Our Ref: 15GCT0065
Your Ref: DA 43-3-2005

RE: Bay Grand Apartments - 2-6 Bay Street Tweed Heads

TTM have been engaged by Heran Building Group to review the proposed changes to the 'Bay Grand Apartments' development located at 2-6 Bay Street Tweed Heads.

Figure 1: Commercial Core Parking Area North

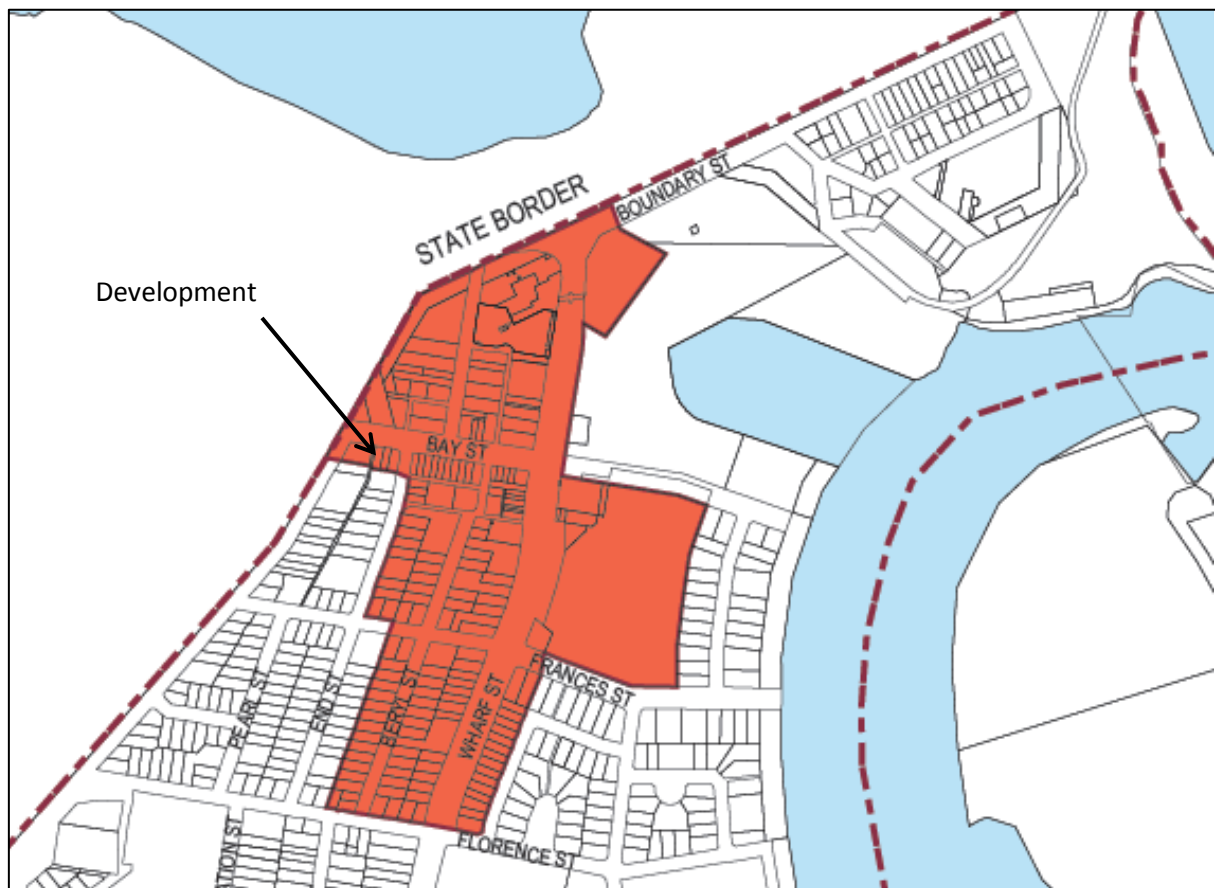
The Tweed City Centre Plan, adopted by TSC as part of the 2012 Local Environment Plan (LEP), contains specific parking rates for developments located within defined commercial core areas. The development is largely contained within the Commercial Core Parking Area - North, as illustrated in Figure 1.

Figure 2: HRV Service Bay Access

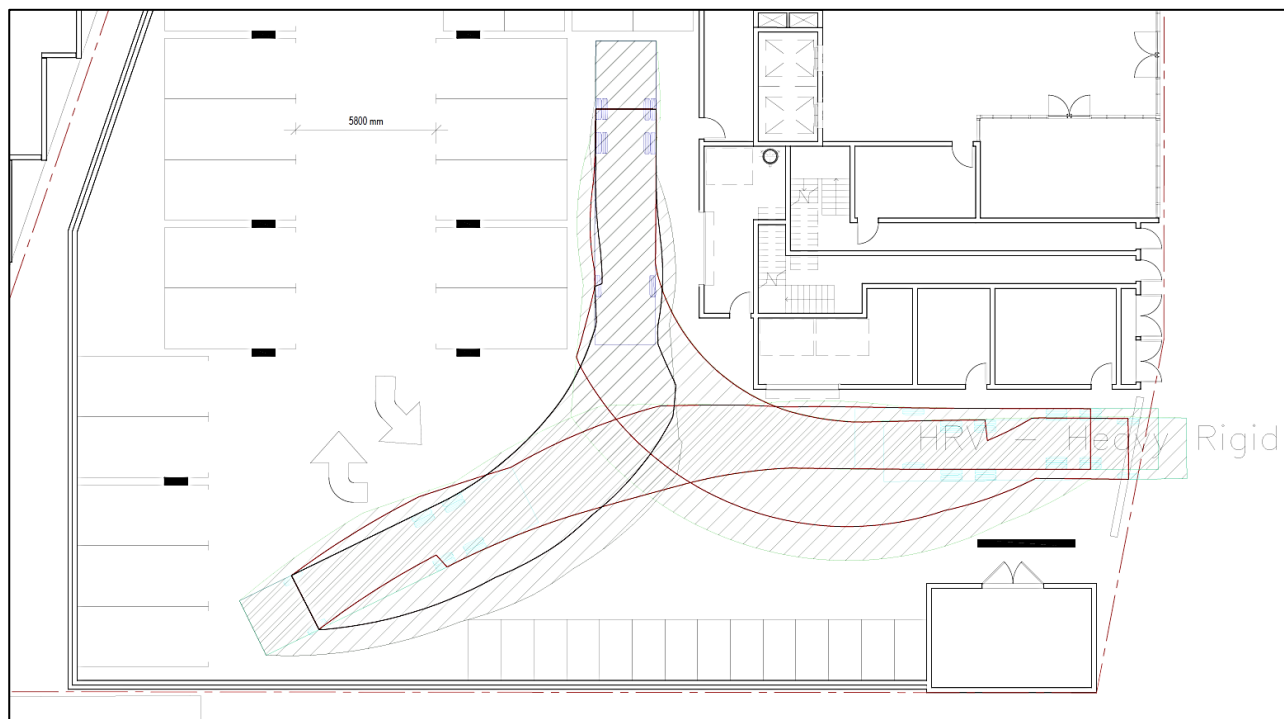
The development provides a HRV service bay, consistent with AS2890.2 requirements. TTM have demonstrated the accessibility of the service bay in Figure 2, allowing for the HRV to enter and exit the development in a forward gear.
